LONDON SCHOOL OF HYGIENE AND TROPICAL MEDECINE, SUDS PLANNING CONDITION 8, 2017/5914/P

Planning Condition 8 (sustainable urban drainage system) of planning permission ref 2017/5914/P dated 27.6.18 was discharge on 18 September 2019 by Camden Council.

The changes are marked onto revision P2 of Wilde Carter Clack's drawing No TP2-WCC-ZZ-ZZ-DR-D.0050 on the following page.

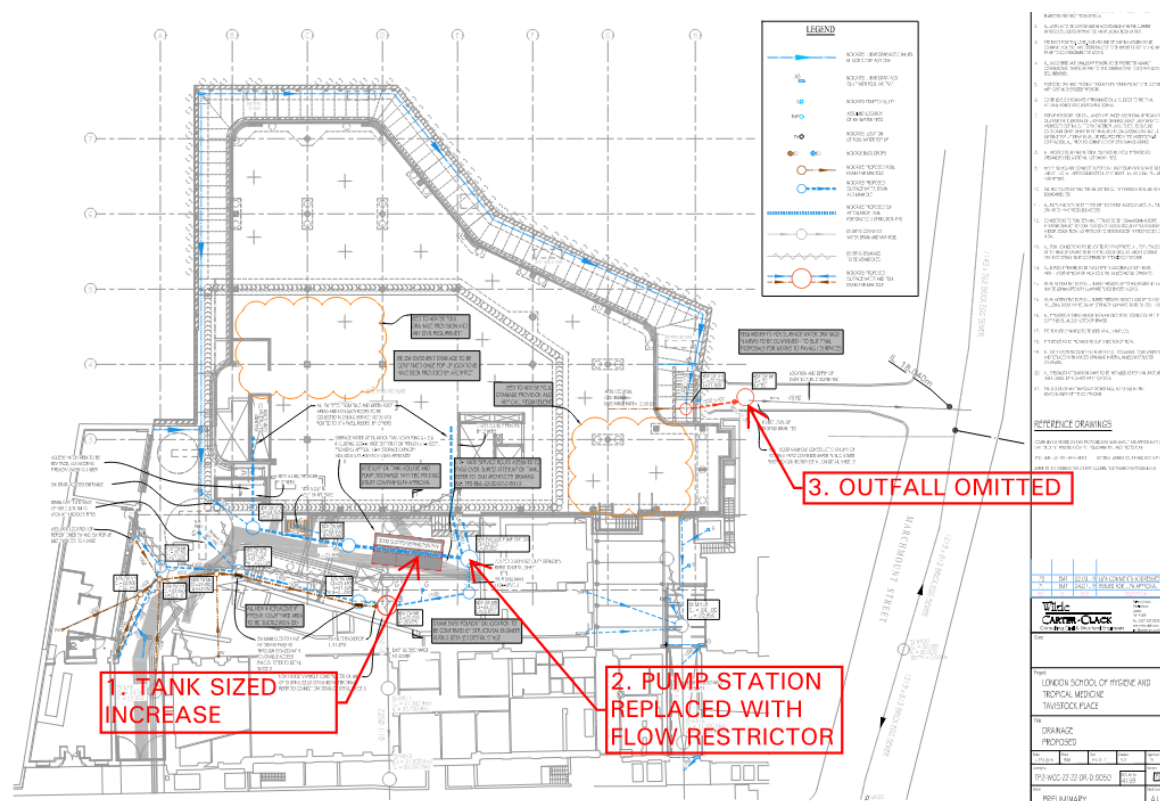
1. The SUDS below ground storage tank size is increased from 12m³ to 24m³ in accordance with the employer's requirements drainage drawing.
2. The SUDS pump station SW MH04 is replaced with a flow restricted manhole with a discharge rate of 28l/s, in accordance with the rate stated in the drainage proforma submitted by email to Aecom, Camden's SUDS advisor, on 22/03/19.
3. The north east outfall to the public sewer in Marchmont Street is omitted
